Subject

Multifunction Solenoid Retrofit Template

Multifunction Coalescer Bracket P/N: 9500240

Figure 1 - Solenoid bracket retrofit instructions

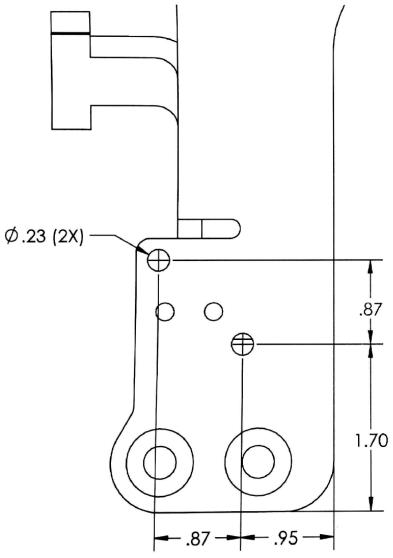
- Air solenoid part number 3550809 is no longer available and is being replaced by current part number 3550881. The bolt pattern differs between the two parts.
- In order to mount a current replacement solenoid, the existing coalescer bracket will need to be modified at the solenoid mount location by drilling additional holes as indicated in Figure 1 below.
